Specification change of Model name and Name plate and Packing label

We would like to inform that we will change Model name and Name plate and Packing label of Optional plug-in module of multi-measuring instrument.

ME96SS Series

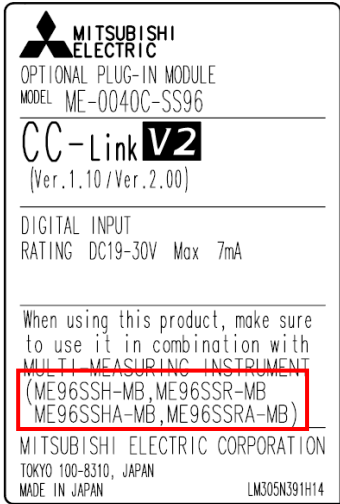
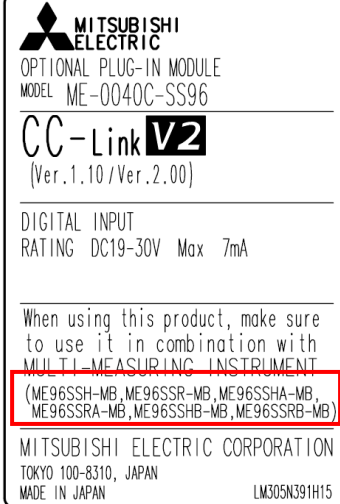
Before change	After change
① Name plate (ME-0040C-SS96, ME-0052-SS96)	 <p>MITSUBISHI ELECTRIC OPTIONAL PLUG-IN MODULE MODEL ME-0040C-SS96 <b>CC-Link V2</b> (Ver. 1.10 / Ver. 2.00) DIGITAL INPUT RATING DC19-30V Max 7mA When using this product, make sure to use it in combination with MULTI-MEASURING INSTRUMENT (ME96SSH-MB, ME96SSR-MB, ME96SSHA-MB, ME96SSRA-MB) MITSUBISHI ELECTRIC CORPORATION TOKYO 100-8310, JAPAN MADE IN JAPAN LM305N391H14</p>	 <p>MITSUBISHI ELECTRIC OPTIONAL PLUG-IN MODULE MODEL ME-0040C-SS96 <b>CC-Link V2</b> (Ver. 1.10 / Ver. 2.00) DIGITAL INPUT RATING DC19-30V Max 7mA When using this product, make sure to use it in combination with MULTI-MEASURING INSTRUMENT (ME96SSH-MB, ME96SSR-MB, ME96SSHA-MB, ME96SSRA-MB, ME96SSHB-MB, ME96SSRB-MB) MITSUBISHI ELECTRIC CORPORATION TOKYO 100-8310, JAPAN MADE IN JAPAN LM305N391H15</p>

※1 The above is an example of ME-0040C-SS96.

※2 The previous product also Can be used for both ME96SSRB and ME96SSHB.
